**Vista 600 Phase 2 Site Plan
13677 S. 600 West**

**EXHIBIT F
SITE PLAN**

C-101

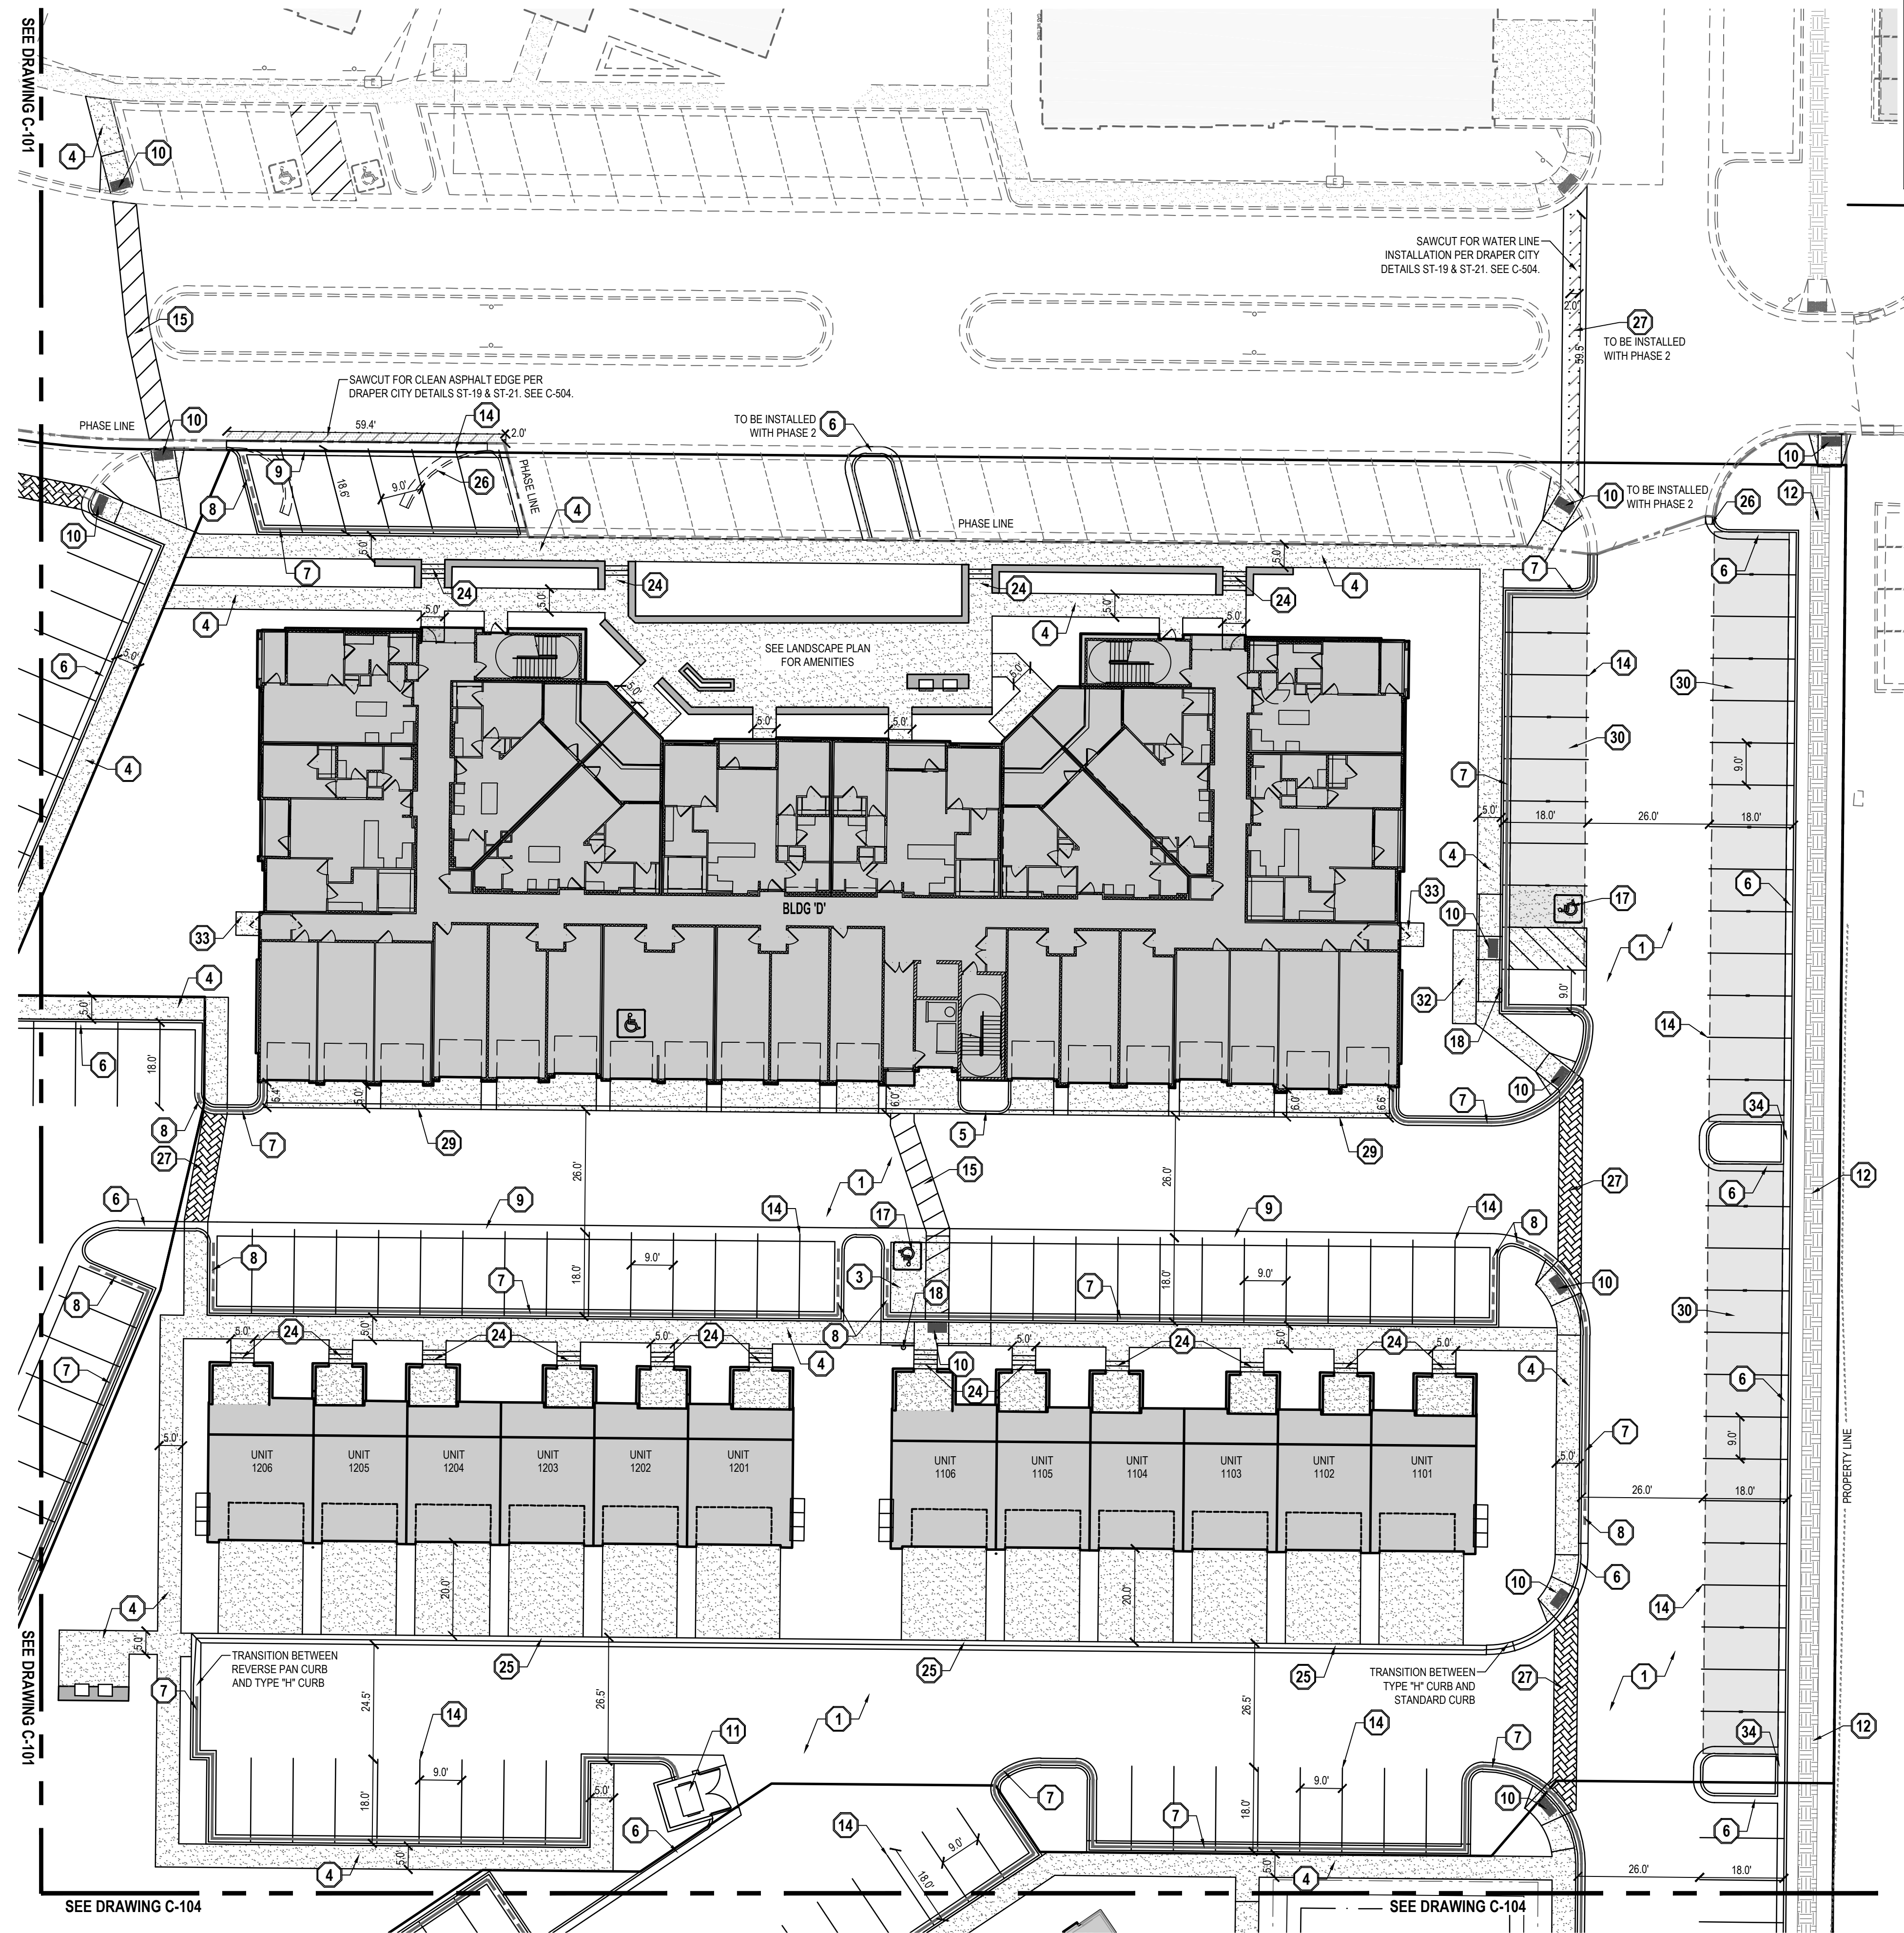
6. Note 18 on sheet C301 indicates landscaping irrigation is to connect to the fire line. Update plan and indicate correct location of irrigation connection – on service line, not fire line.

2. That all requirements of the geotechnical report are satisfied throughout the development of the site and the construction of all buildings on the site.
3. That note 18 on sheet C301 is updated to indicate the correct location of the irrigation water connection to a service line and not a fire line.
